PLAN SHOWING PROPOSED IMPROVEMENTS PREPARED FOR:  
**HAROLD WARD**

94 WOODVILLE ROAD  
 ASSESSOR'S PLAT 9A LOT 21  
 TOWN OF RICHMOND, RHODE ISLAND

SHEET 1 OF 1

DEPARTMENT OF ENVIRONMENTAL MANAGEMENT  
 OFFICE OF WATER RESOURCES  
 FRESHWATER WETLANDS PROGRAM  
 APPROVED WITH CONDITIONS  
 AS SPECIFIED IN THE LETTER OF APPROVAL  
 DATED NOV 13 2008 FILE # 08-0318  
 NO CHANGES ALLOWED WITHOUT PRIOR APPROVAL  
 APPROVED PLANS MUST BE AT CONSTRUCTION SITE.

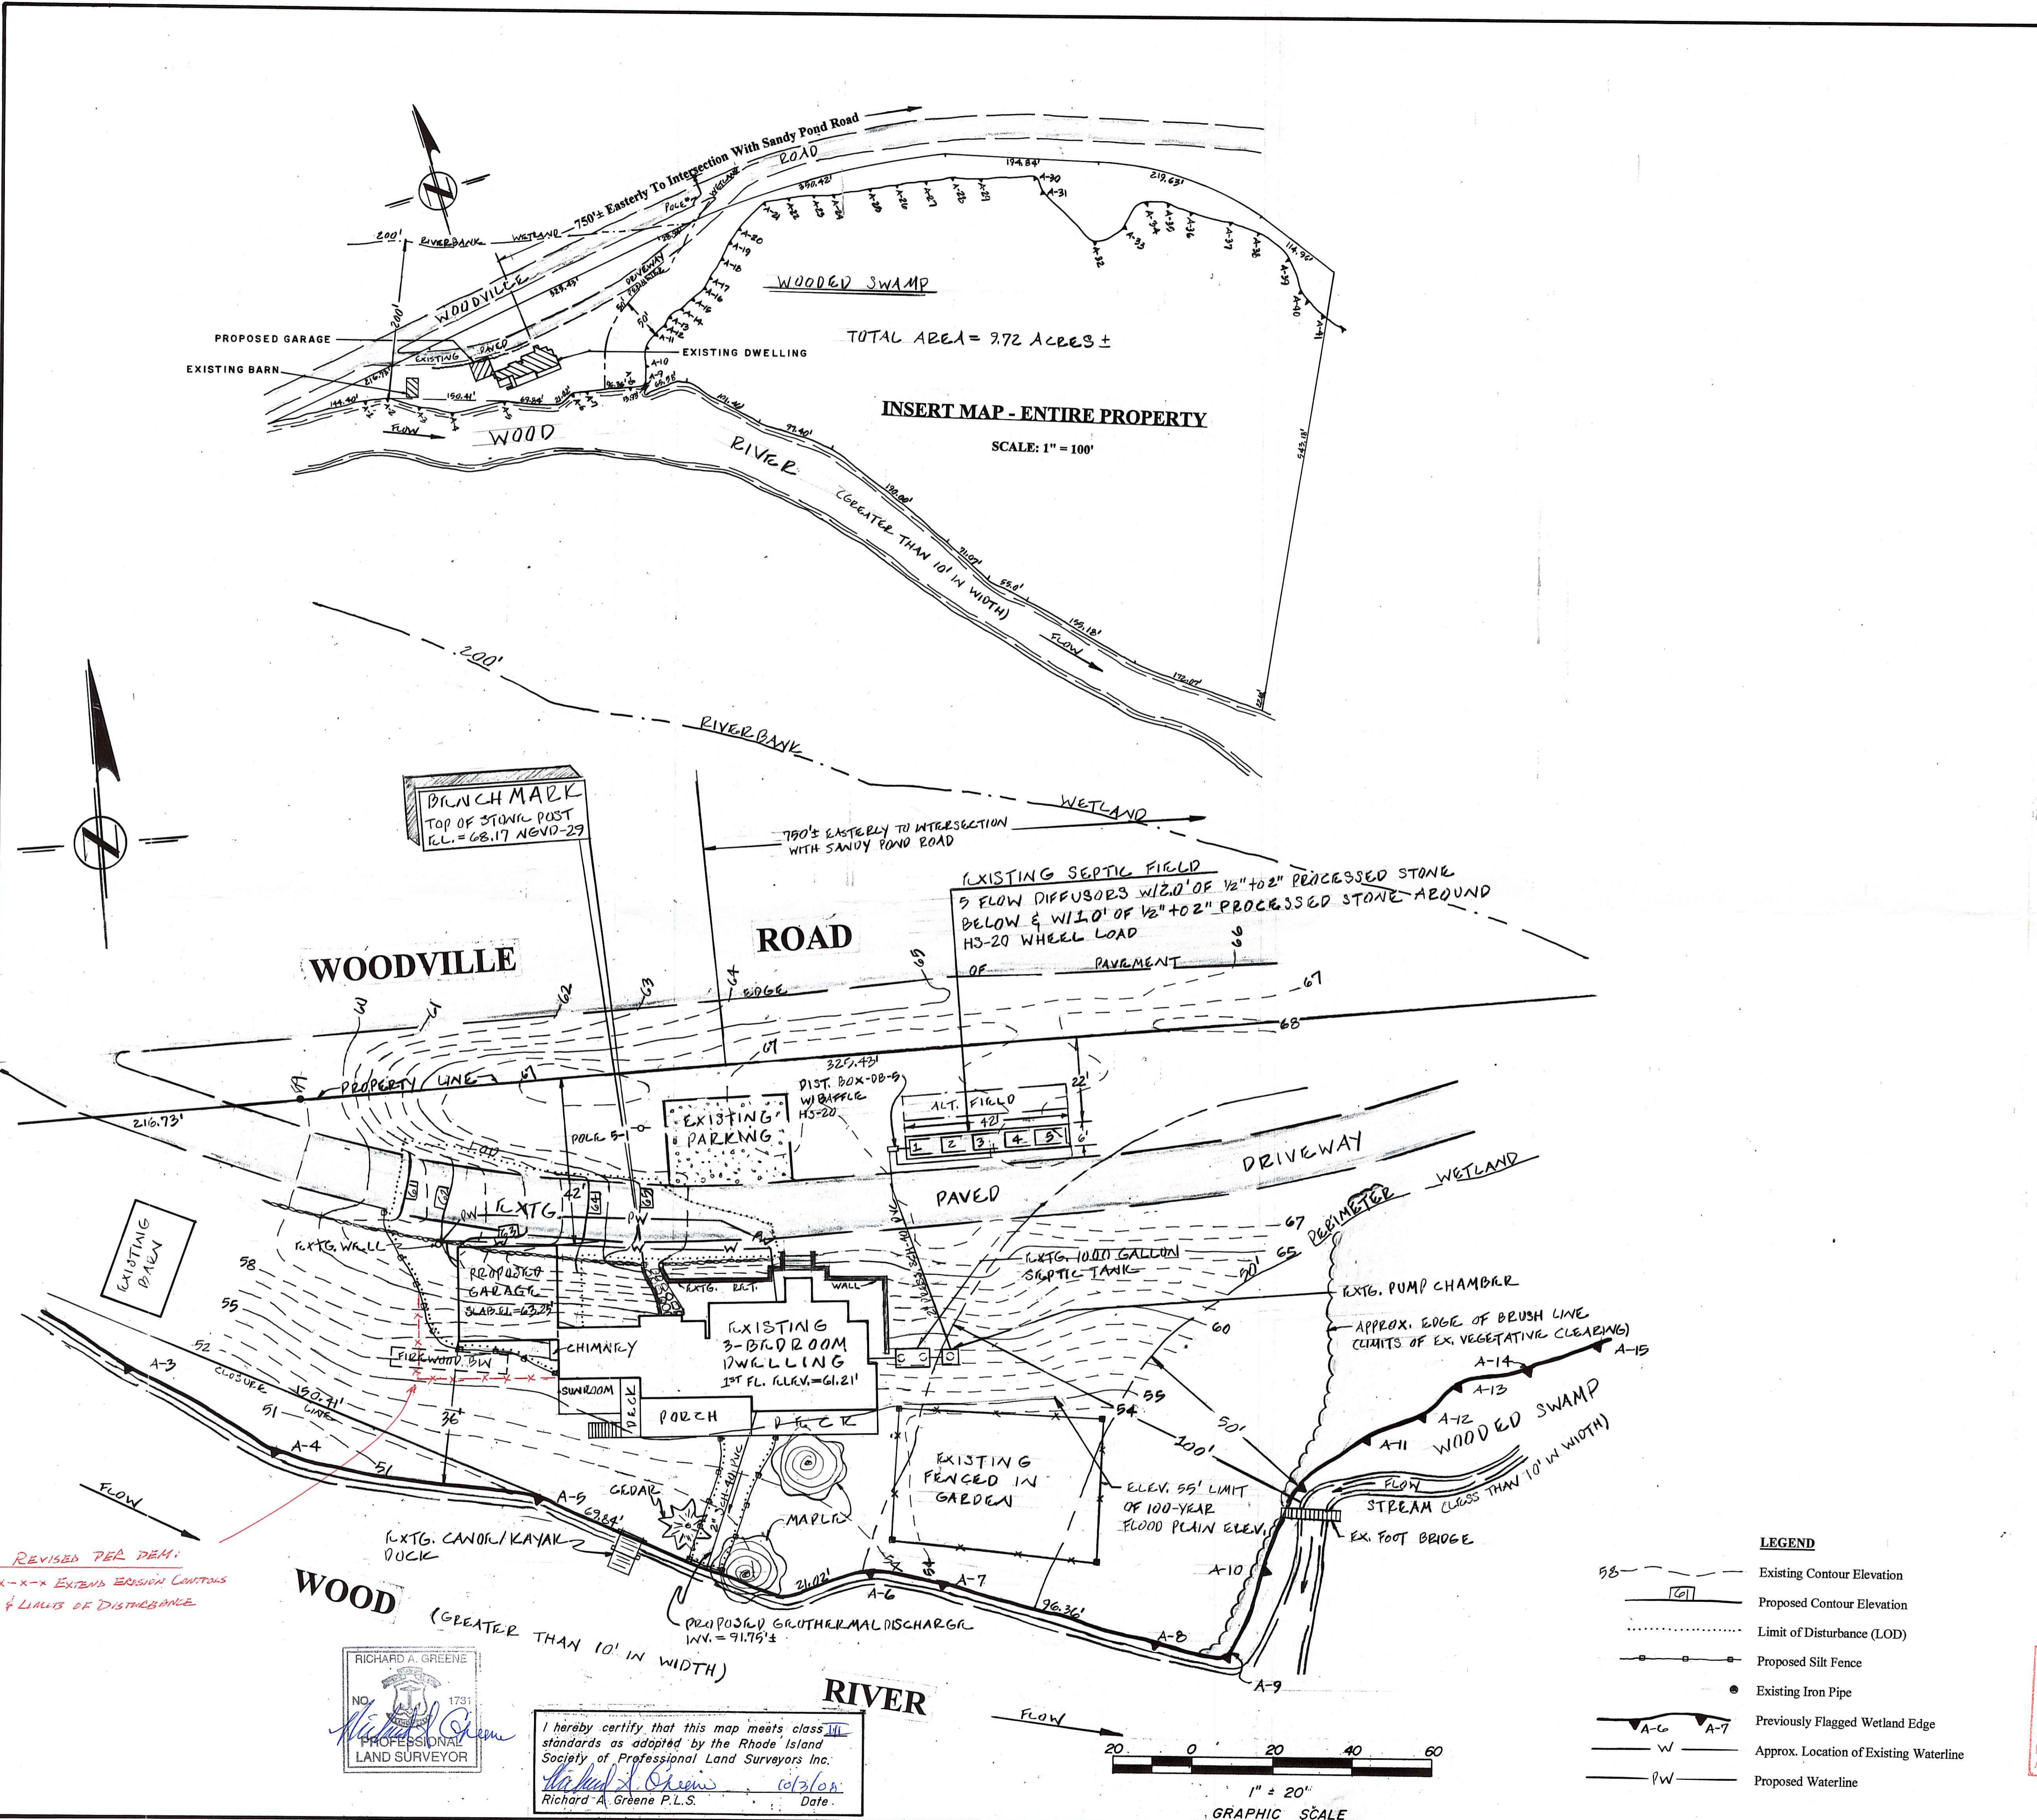
REVISED PER DEMT:  
 x-x-x EXTEND EROSION CONTROL  
 & LIMITS OF DISTURBANCE
